Browns Ferry Nuclear Plant, Units 1, 2, and 3
Renewed Facility Operating License Nos. DPR-33, DPR-52, and DPR-68
NRC Docket Nos. 50-259, 50-260, and 50-296

Subject: **Response to NRC Request for Additional Information Regarding the License Amendment Request to Adopt NFPA 805 Performance-Based Standard for Fire Protection for Light Water Reactor Electric Generating Plants for the Browns Ferry Nuclear Plant, Units 1, 2, and 3 (TAC Nos. MF1185, MF1186, and MF1187) - Set 1**

TVA Responses to NRC Request for Additional Information: Set 1 (nominal 60-day)

A conceptual sketch of the modified portion of the circuit design is provided below.

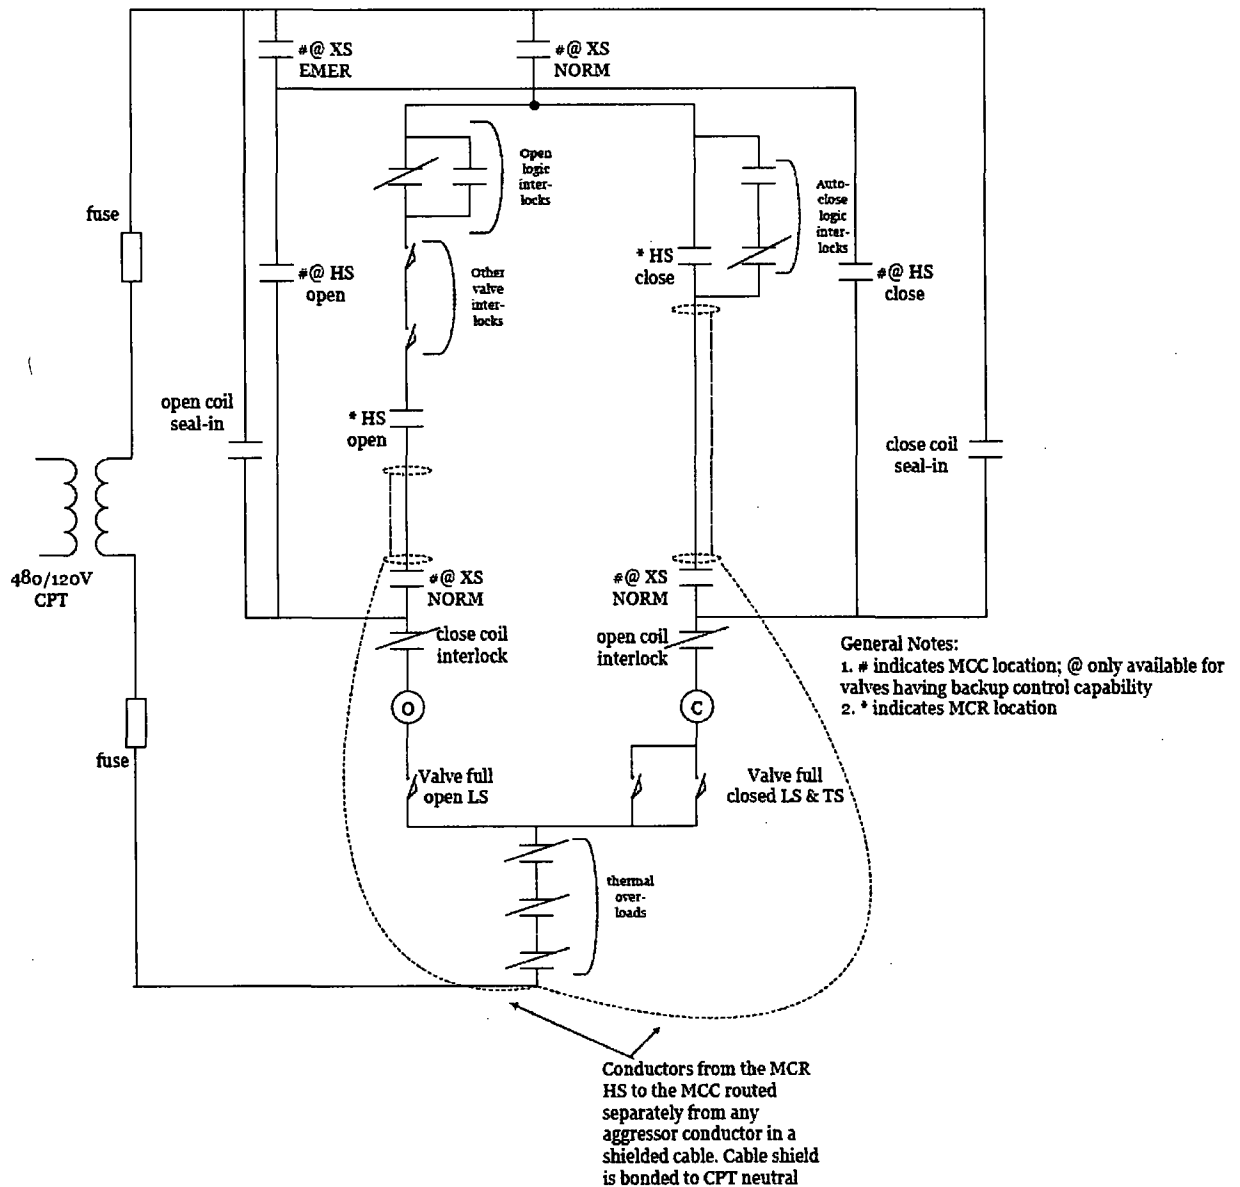
LAR Attachment S, Table S-2, Items 9a through 9f, describe ten RHR valves being modified to prevent water hammer. Provide more detail of the modifications with regard to specific circuit changes and how these modifications will prevent spuriously opening the valves. Include in the description the use of insulated shield cables and how they function to protect the valve circuit.

Although the designs for these modifications are not finalized, the current plans are that the modifications will reconfigure the valves' control circuits in four major ways, as described below, to reduce the probability of fire-induced spurious opening. Each of these valves utilizes 120 volt (V) AC control power from its own ungrounded control power transformer (CPT).

- The local control station handswitches (HSs) will be removed or abandoned. This aspect of the modification eliminates a target cable vulnerability where fire-induced damage could spuriously open the valve.

- The valve position and torque switches used in the motor contactor circuit will be moved to the neutral side of the motor contactors. With the switches wired in this manner, a postulated single hot short to the limit switch (LS) or torque switch (TS) would not result in spurious opening of the valve.

- Logic relay and valve interlock contacts in the OPEN circuit will be rewired to the hot side of the MCR HS contacts. Once rewired, postulated shorts around the logic relay and interlock contacts would be prevented by the normally open MCR HS contacts from causing spurious valve operation.

- The circuit conductors between the MCR HS contacts and the motor control center (MCC) will be routed in a cable separate from any CPT hot conductors, either in a dedicated raceway or in control power cable trays limited to cables carrying no more than 30 amperes (amps). The new cable will have thermoset insulation and will have an integral, insulated braided shield. The cable shield will be bonded to the CPT neutral, such that a postulated hot short (i.e., inter-cable or ground fault equivalent hot short) would physically make contact with the reference grounded shield, thereby causing electrical protective device clearing, prior to contacting the target circuit conductor that could cause spurious valve operation.

The insulated braided shield will be sized so that it is protected by the CPT neutral fuse if routed in a dedicated conduit or the larger of the CPT neutral fuse or a 30 amp protection device if routed in control power cable tray. The new insulated braided shield cable will not be routed in the same fire areas where the cable carrying the valve LS/TS conductors is routed, with the exception of the MCC location fire area.
